# UJF-3042HG / UJF-6042 テーブルタップ位置の訂正

さて、UV インクジェットプリンタ UJF-3042HG/6042(取扱説明書 D202465-11) のタップ位置についての記載に、誤記がございました。  
訂正し、お詫び申し上げます。

# UJF-3042HG / UJF-6042 Correction of Table Tap Position

• UJF-3042HG

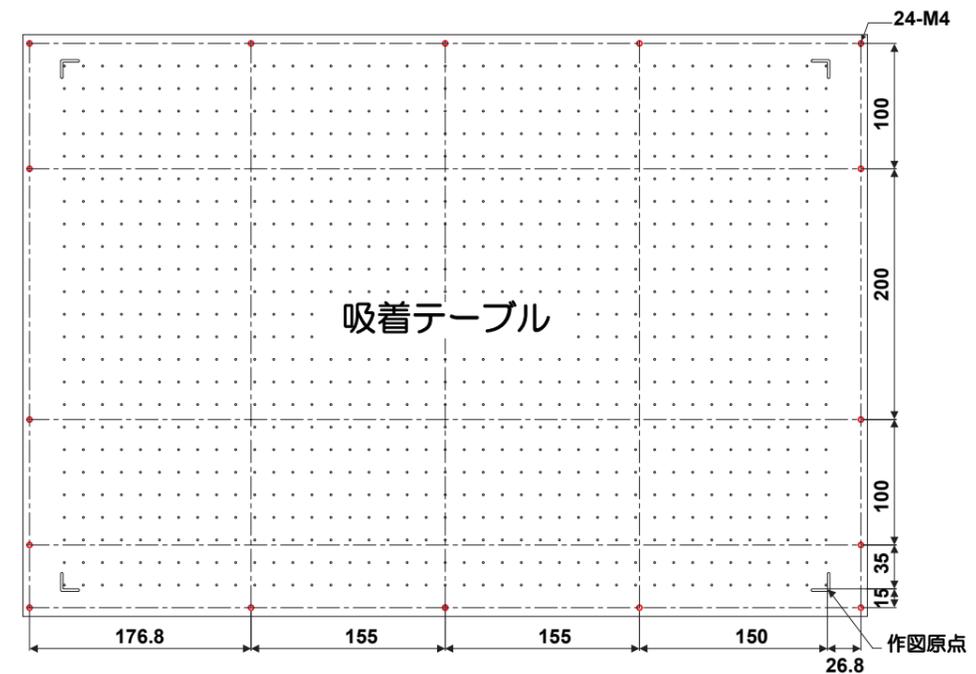
メディアをセットするためのテーブルや吸着テーブルにはそれぞれ以下の寸法で M4 タップ (UJF-3042HG: 12 箇所、UJF-6042: 16 箇所) が開いています。  
タップ位置の図面データは、ミマキエンジニアリングダウンロードページ (<http://www.mimaki.co.jp/download>) の「マニュアル」よりダウンロードできます。

- 重要!**
- 図のタップ位置 (○) 以外にもタップ穴 (○) が開いていますが、それらの穴は製造工程で必要な穴のため、使用しないでください。
  - 指定のタップ穴 (○) 以外は、断りなく位置を変更する場合があります。

### • UJF-3042HG

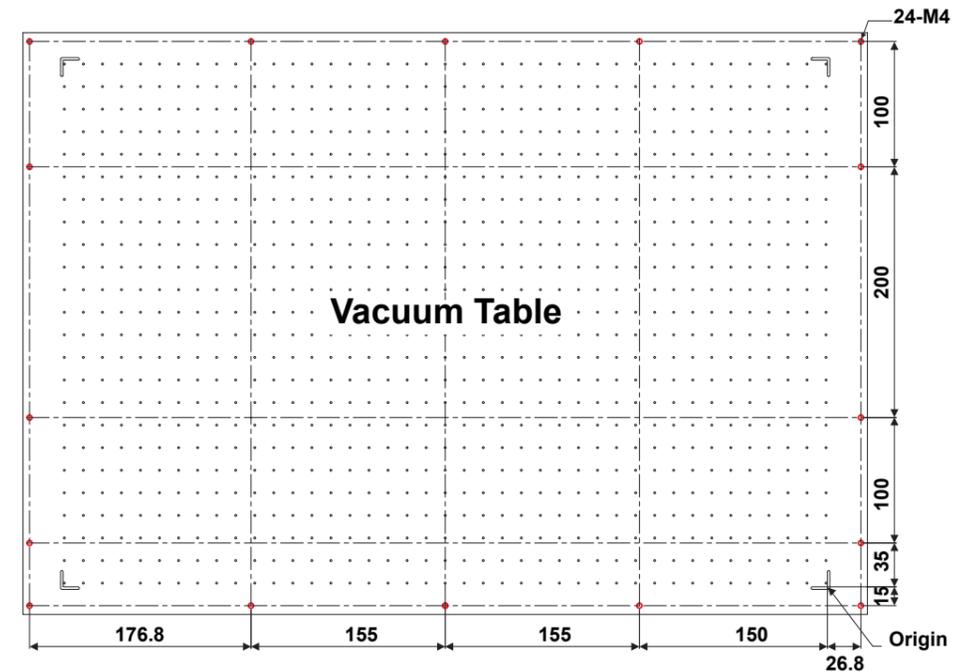
We regret to inform you there was a mistake in the description of the tap positions of our UV inkjet printer UJF-3042HG/6042(Operation Manual D202466-11). We have corrected this mistake and apologize for any inconvenience.

The table and the vacuum table on which the media set have the M4 tap (UJF-3042HG: for 12 positions, UJF-6042: for 16 positions) of the size below respectively. You can download data illustrating the tap positions from the "Manual" section of the Mimaki Engineering download page (<http://eng.mimaki.co.jp/download/>).

- Although tap holes (○) are open except the tap position in the drawing (●), they are necessary in the production process. Therefore, please do not use them.
- We may change the position except specified tap holes (●) without prior notice.
